CITY PLAN COMMISSION REPORT

Kenwood II

2.1, 2, & 3 CD-CPC-2021-00118, 119, & 120
Rezoning to R-1.5,
Area Plan Amendment, and
Development Plan

Case Number: CD-CPC-2021-00119

SITE PLAN

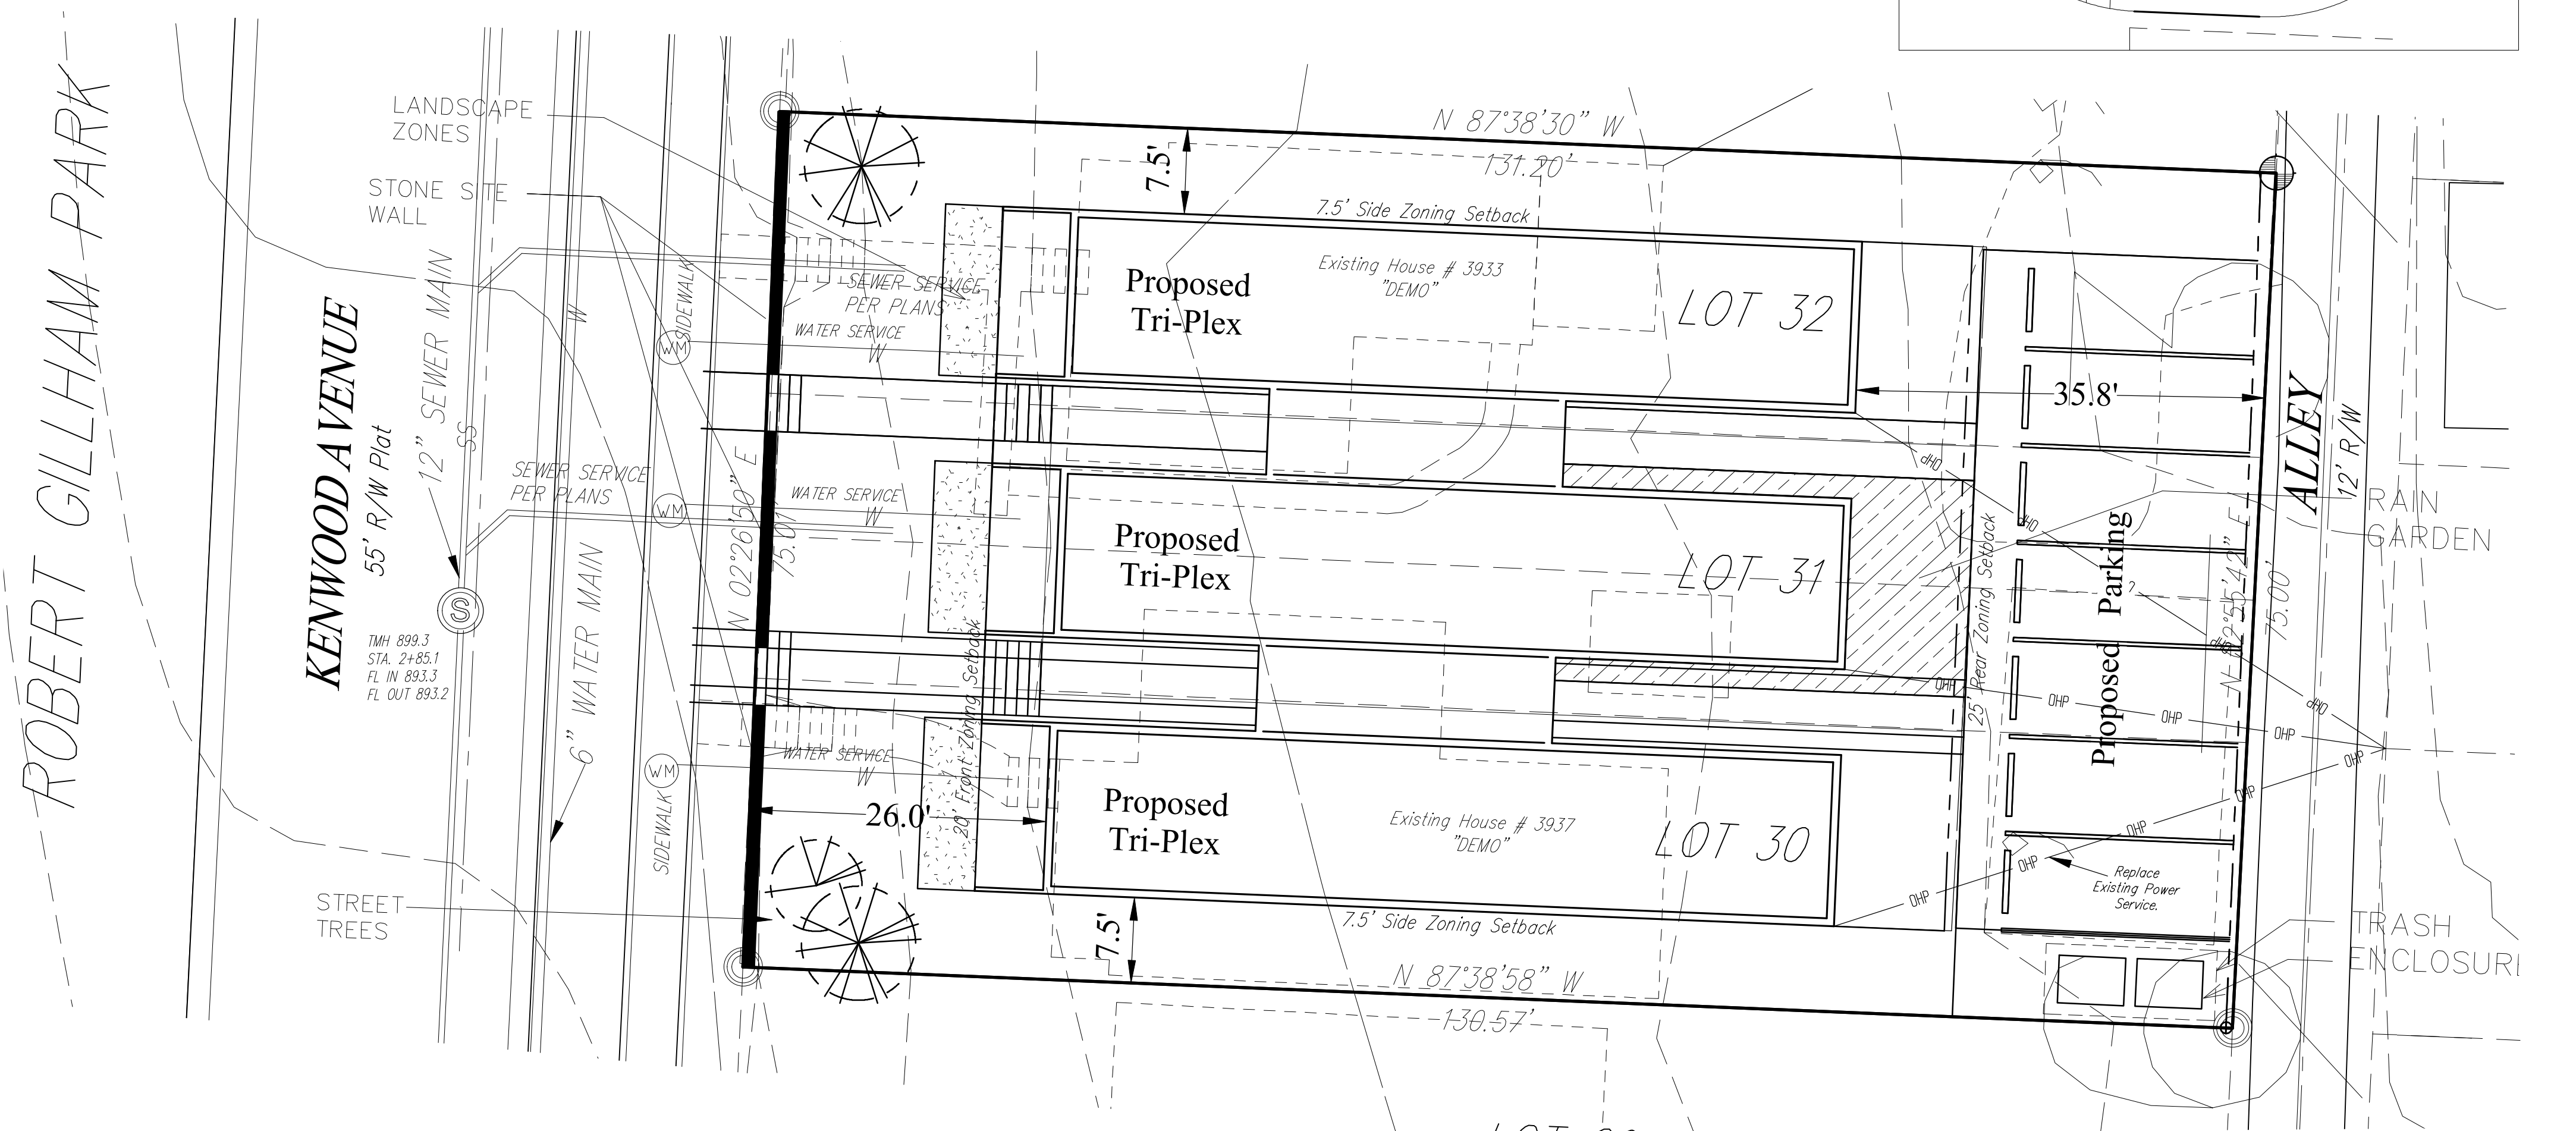
1. The developer shall submit an affidavit, completed by a landscape architect licensed in the State of Missouri, verifying that street trees have been installed in accordance with the approved street tree planting plan and are healthy prior to Certificate of Occupancy. (8/25/2021)
2. Mechanical equipment and utility cabinets shall comply with 88-425-08-B and 88-425-08-D. (8/25/2021)

3. Historic Preservation The two houses are part of the South Hyde Park Historic District. The district is only on the national register and not on the local, so no review is required by the Historic Preservation commission. Though not a requirement, staff would recommend the applicant use similar exterior materials and paint colors that are on the buildings at 3915-23 Kenwood to allow the modern design to blend in with the neighborhood. (7/09/2021)

4. The developer shall submit a Storm Drainage analysis from a Missouri-licensed civil engineer to the Land Development Division evaluating proposed improvements and impact to drainage conditions. Since this project is within a "Combined Sewer Overflow" (CSO) district, the project shall be designed to retain rainfall of 1.5 inch depth over the entire site to simulate natural runoff conditions and reduce small storm discharge to the combined sewer system. Manage the 10-year storm and 100-year storm per currently adopted APWA standards. The analysis shall be submitted prior to issuance of any building permits, and the developer secure permits to construct any improvements required by the Land Development Division prior to issuance of any certificate of occupancy. (7/15/2021)

11. • The expectation is the project will meet the fire flow requirements as set forth in Appendix B of the International Fire Code 2018. (IFC-2018 § 507.1) (7/22/2021)

12. • Fire hydrant distribution shall follow IFC-2018 Table C102.1 (7/22/2021)
13. • Buildings equipped with a fire standpipe system shall have an operable fire hydrant within 100 feet of the Fire Department Connection (FDC). (IFC2018 § 507.5.1.1) (7/22/2021)

15. • Aerial Fire Apparatus access roads shall be provided for any building that is 30 feet in height or greater. Aerial Fire Apparatus Roads are a minimum 26 feet wide, at least 15 feet away from the building but not more than 30 feet from the structure. (IFC-2018 § D105). (7/28/2021)

16. • The turning radius for fire department access roads is 30 feet inside and 50 feet outside radius. (IFC-2018: § 503.2.4) (7/28/2021)
17. Fire Department access roads shall be provided prior to construction/demolition projects begin. (IFC-2018 § 501.4 and 3310.1; NFPA 241-2013 § 7.5.5) (7/28/2021)

19. The developer shall ensure that water and fire service lines should meet current Water Services Department Rules and Regulations.
<https://www.kcwater.us/wp-content/uploads/2019/04/2018-Rules-and-Regulations-for-Water-Service-Lines.pdf>
(8/25/2021)

Notes: 8/11/21
Water/Sewer: Utilities are existing, there are no PROPOSED water mains, sewer mains or hydrants for this property.

Parkland Dedication Requirements: The developer will pay the Parkland Dedication Fee(s) assessed by the City.

Parking Compliance: the developer has entered into a parking agreement with a property located 75' north of the subject property for two surface parking spaces. The property address of where the two surface parking spaces are located is 3923 Kenwood Avenue, KC, MO 64110.
